GOLD PARK HOMES

KLEINBURG GLEN VAUGHAN, ON

SITE PLAN

| DRAWN BY | \$CALE |
|----------------------|------------|
| PROJECT No. 14043 | LOT NUMBER |

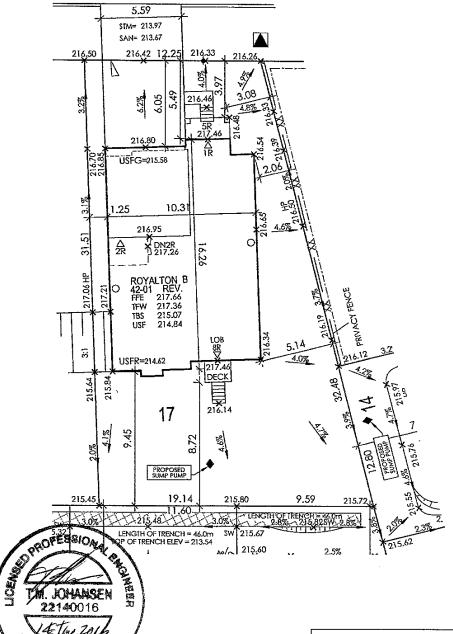
THE PROPOSED LOT GRADING AND DRAINAGE IS APPROVED AS BEING IN CONFORMITY WITH THE OVERALL APPROVED GRADING PLANS FOR THE SUBDIVISION.

THIS REVIEW DOES NOT WARRANT THAT OTHER INFORMATION SHOWN ON THIS DRAWING IS ACCURATE OR COMPLETE. SOLE RESPONSIBILITY FOR THE DESIGN AND DETAILS SHALL REMAN WITH THE DESIGNER.
